# PERMIT

A REPAIR

SEWAGE DISPOSAL SYSTEM

SUBDIVISION \_\_\_\_\_ ROAD 3560 Church Road LOT \_\_\_\_\_

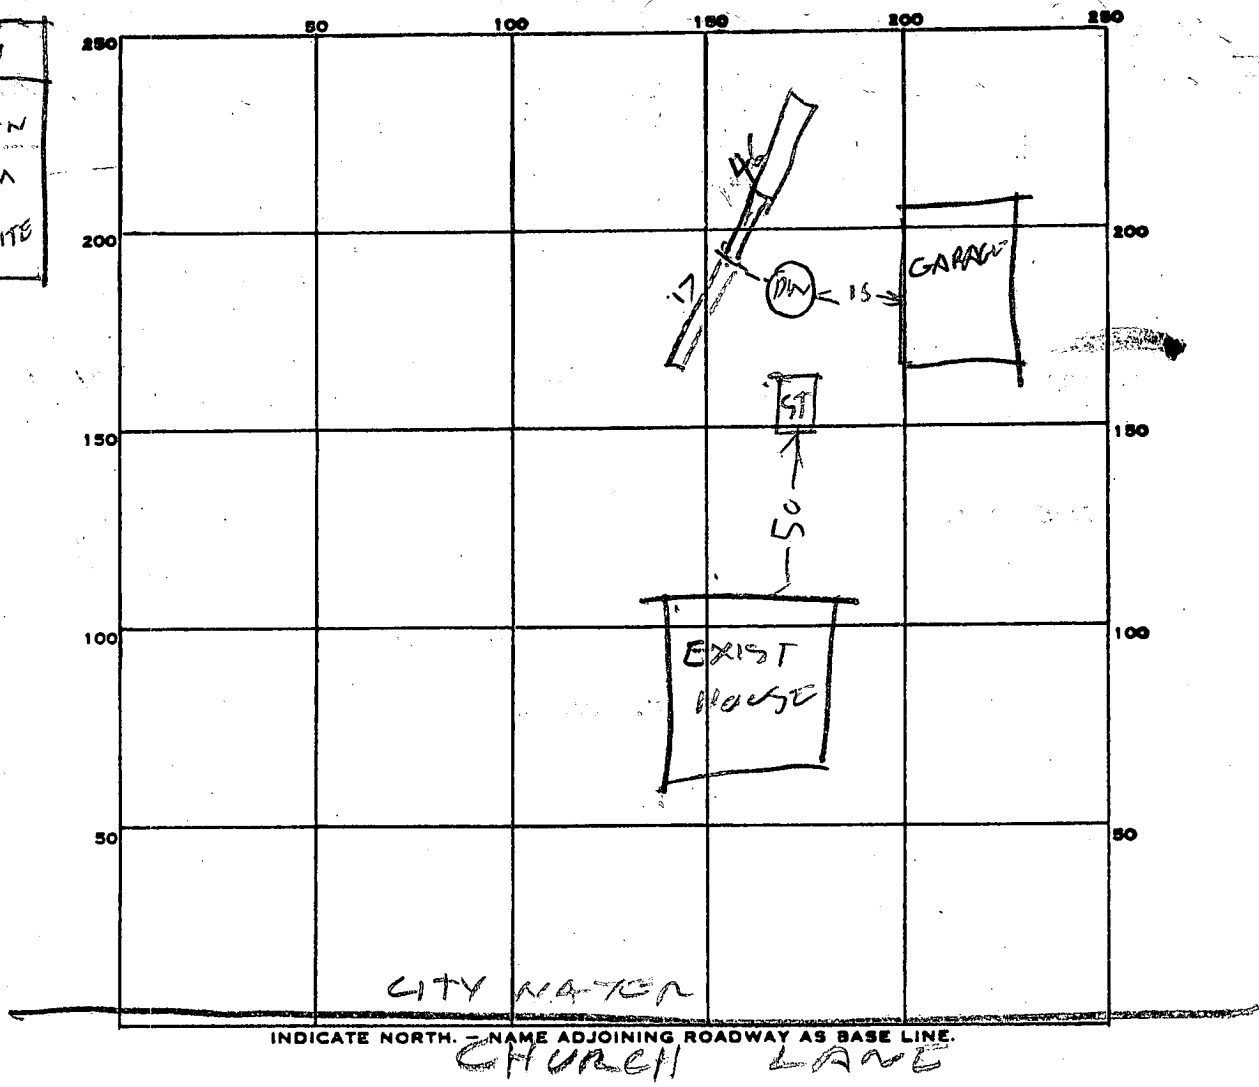
REPAIR - CALL FOR INSPECTION WHEN GROUND IS OPENED UP SO SANITARIAN CAN RECOMMEND

REPAIR. 3/27/86 - TRENCH OFF EXISTING

DRY WELL 500 SQFT ABSORBENT AREA ONE SIDE  
TRENCH 10 FT DEEP 2 FT WIDE 8 FT STONE 63 FT LONG

REMARKS 3/27/86<sup>AM</sup> OLD DW 13 FT DEEP FOR SEVERAL YEARS, SOIL OK

FORTRENCH SYSTEM - FINISH DIGGING TRENCH ADD

STONE & CALL.

3/27/86<sup>AM</sup> TRENCH DUG & MOST OF STONE ADDED

FINISH ADDING STONE RH
